TSB-GM260 In Relation to Clutch Kit Part No. KGM26010-1A

This Xtreme Outback performance clutch kit is an upgrade from the original 260mm friction diameter to a larger 275mm friction diameter.

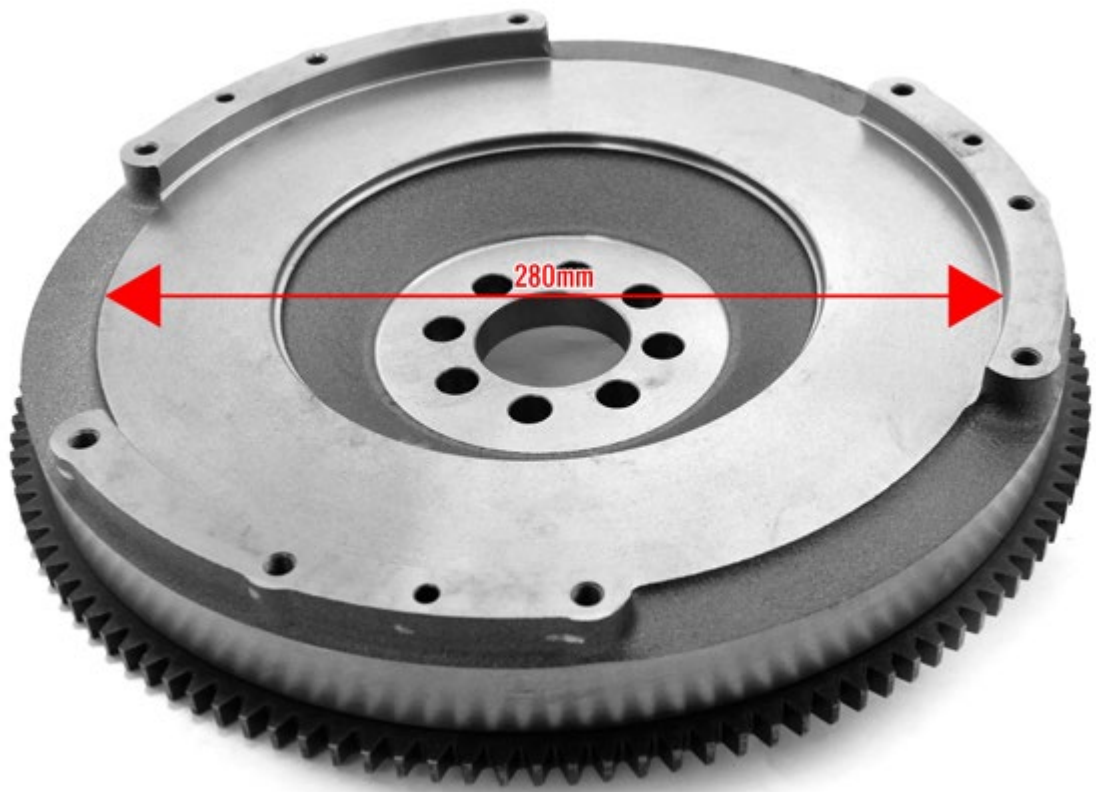
In order to correctly install this performance clutch kit, the inner diameter of the flywheel must be machined to 280mm to clear the larger pressure plate and friction disc.

Failure to bore this diameter out may cause fitment issues and void warranty.
